AMENDMENTS TO THE DRAWINGS

Inventor: Kyle K. Kirby
METHODS OF FORMING VIA PLUGS
Atty Docket No. 400.231US01 Serial No. 10/613,235

ANNOTATED MARKED-UP DRAWINGS

Fig. 5

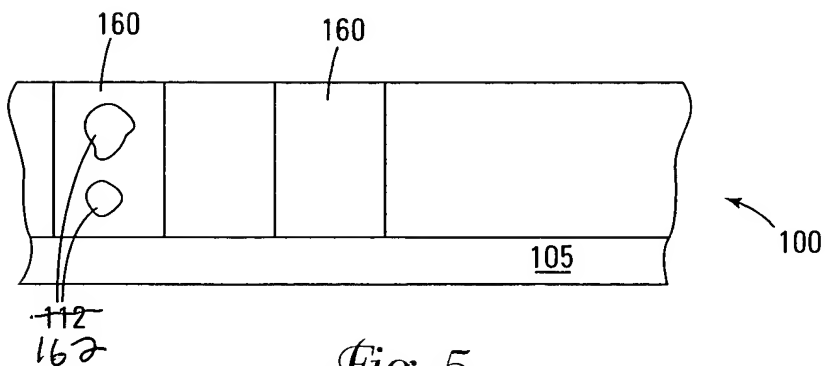
Figures 5 and 7 have been amended. In Figure 5, reference number 112 is replaced with reference number 162 to conform Figure 5 to paragraph [0027] of the Specification. In Figure 7, reference number 600 is replaced with reference number 700 to conform Figure 7 to paragraph [0029] of the Specification, and to overcome the fact that reference number 600 does not appear in the Specification. The amendments are shown in the attached annotated marked-up drawing sheets and are included in the attached replacement sheets. Applicant respectfully submits that the corrections are apparent from reading the Specification in conjunction with the drawings, and, as such, the corrections are fully supported by the Specification as filed.
